NUCLEAR REGULATORY COMMISSION

ADVISORY COMMITTEE ON REACTOR SAFEGUARDS

245TH MEETING

DATE: September 4, 1980 PAGES: 1 thru 308

PERCH BOTTOM Reactor Protection System Trip Discharge Headers

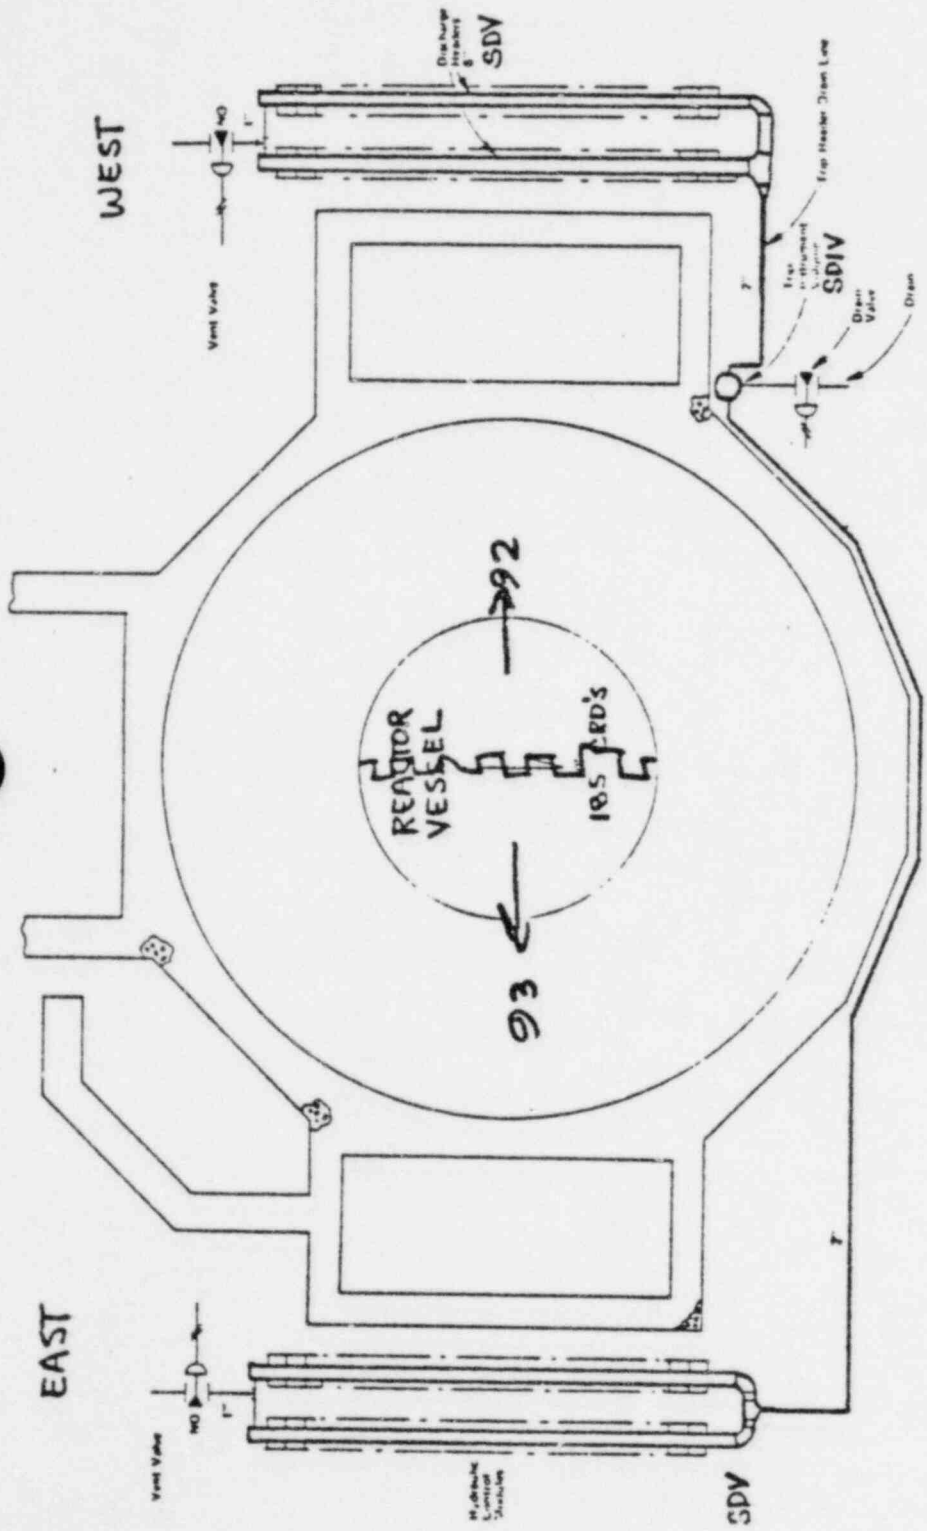
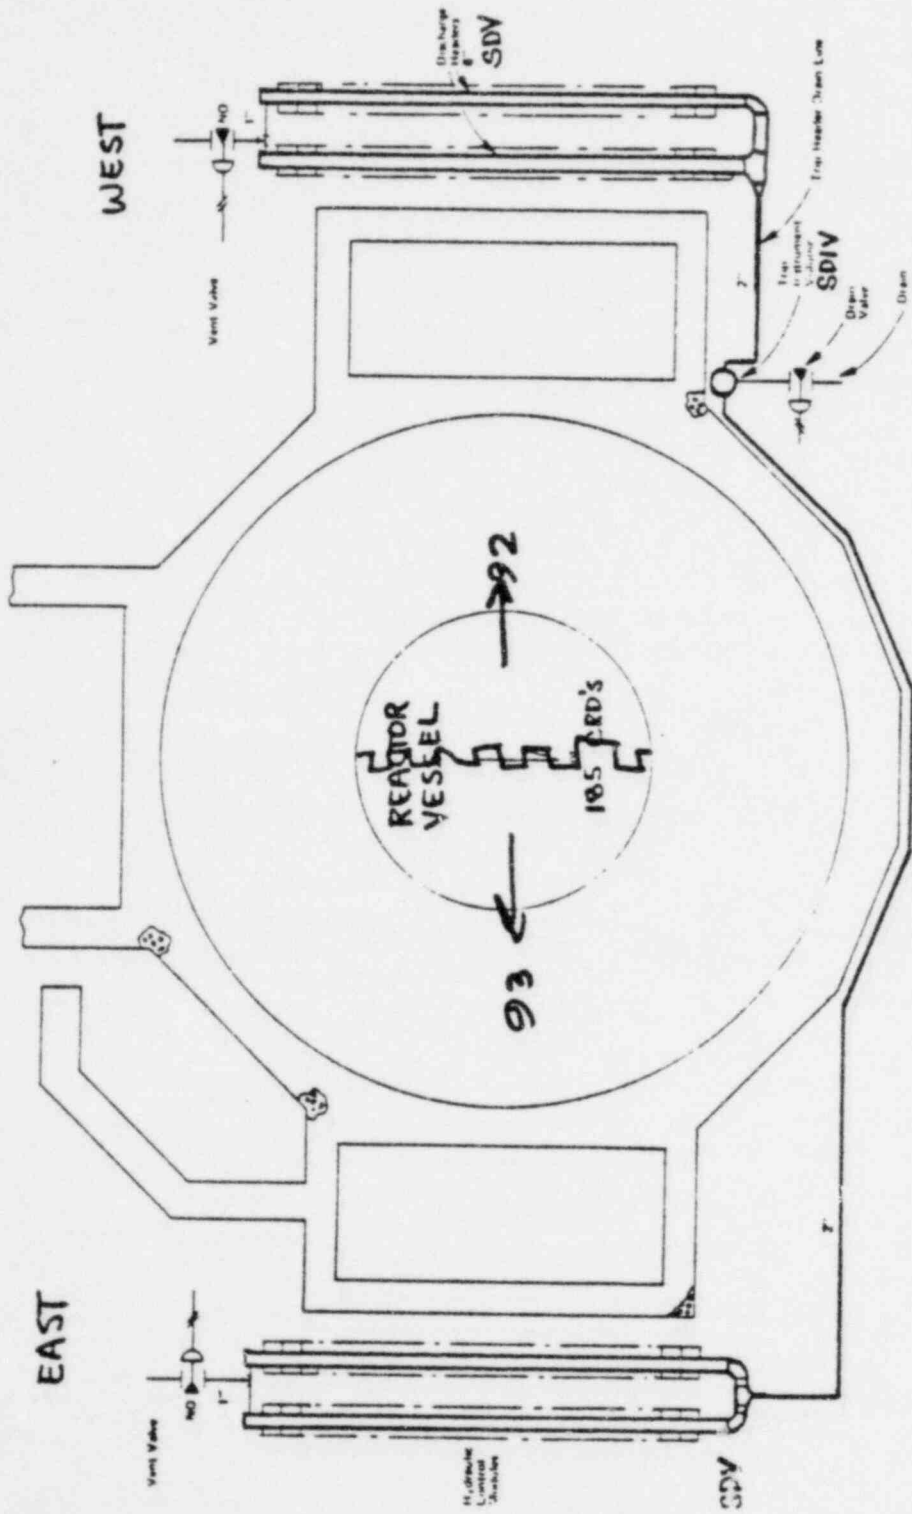
1 you need to look at the layout, and I have a drawing here of
2 Peach Bottom, but it is very, very similar for Browns
3 Ferry. This is a plan view looking down from above the
4 reactor vessel, and off to the side here are the hydraulic
5 control units for each one of the rods.

GE RECOMMENDED SDV CONFIGURATION

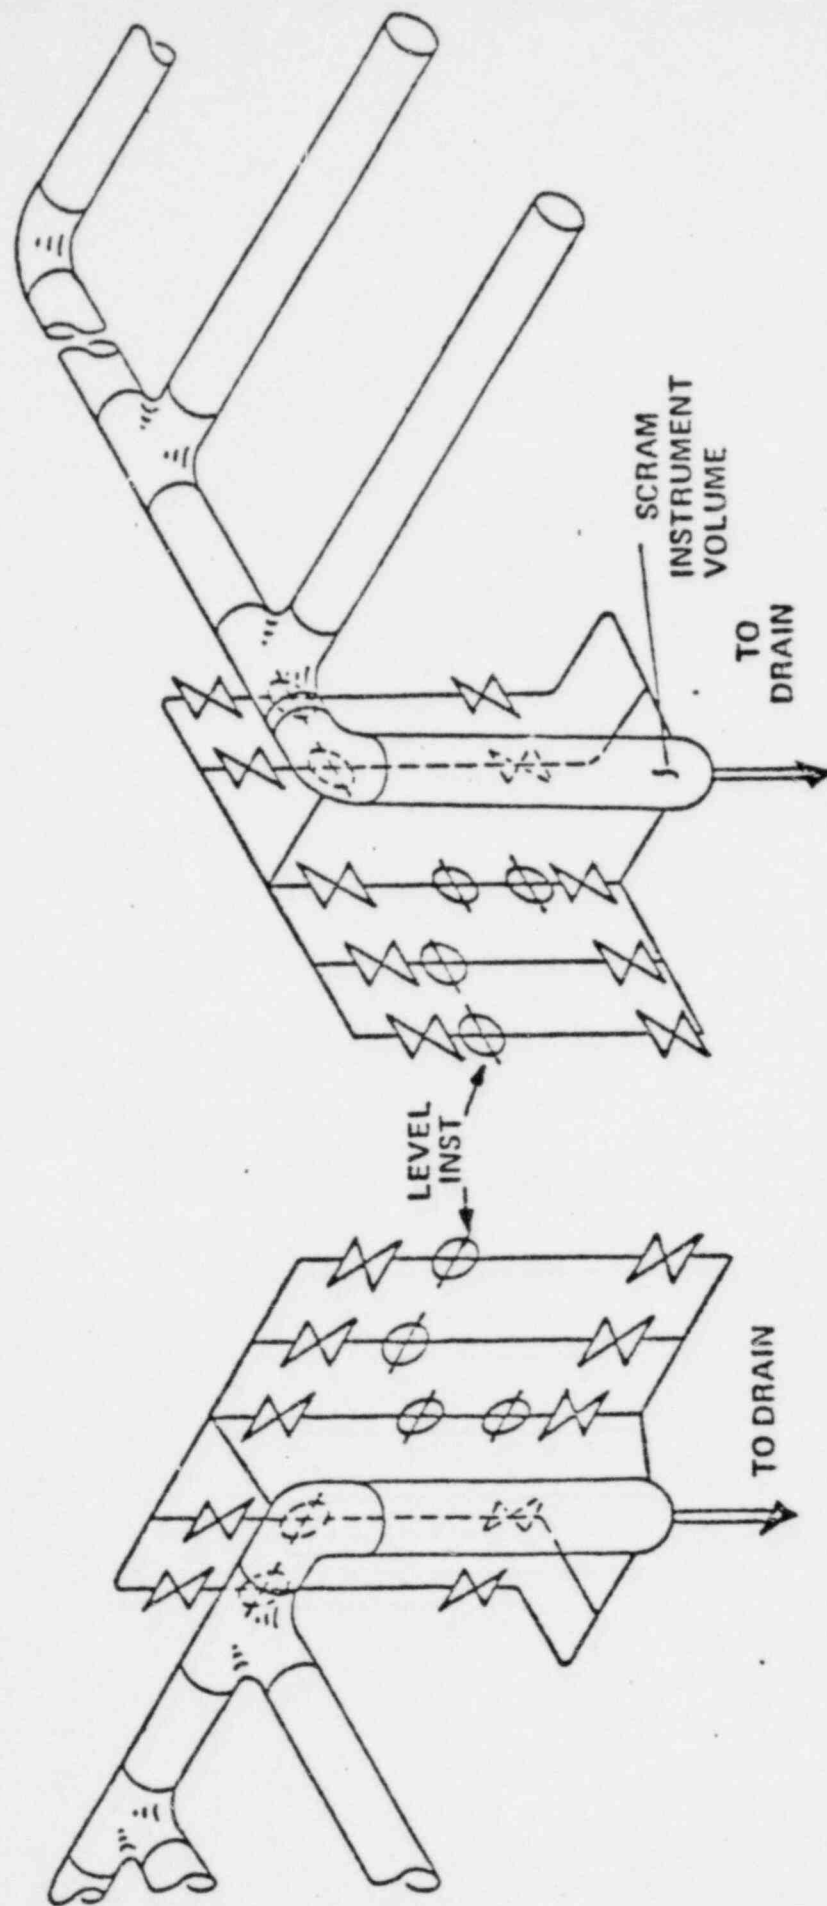
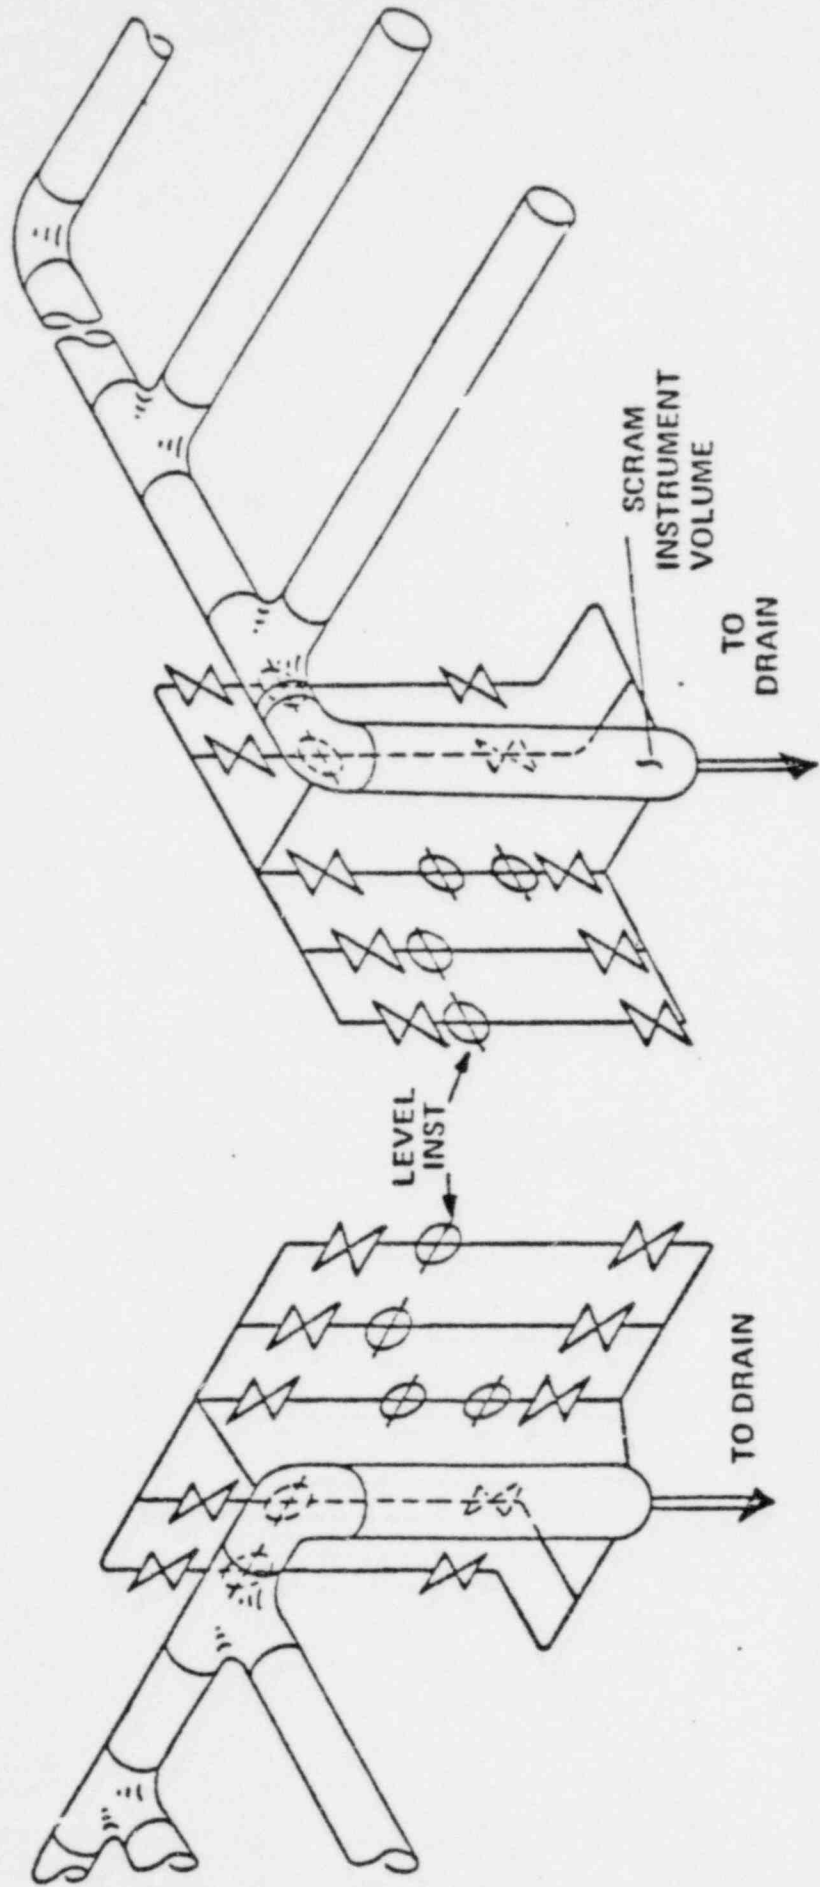
4 This is the hockey stick arrangement that exists
5 on the newer plants. This is the scram volume, and then the
6 instrument volume is an integral part. It has no drain line
7 between the two. Therefore, any water that gets in the
8 system, because it is slow, will drain into the instrument
9 volume and therefore you cannot have the situation where
10 there is water up here and not down here.

11 And that would be independent of a vent or a drain
12 on the system. It would not matter if the vent drain
13 worked; water would still fall to the lowest point, and then
14 the instrumentation they showed here has been slightly
15 modified to not connect with the drain line any more. It
16 connects directly with the instrument volume.

17 And this was, I think, an attempt to correct the
18 water hammer problems at Brunswick and Hatch. It is not a
19 definite solution because no one really knows what caused
20 the problem at this point.
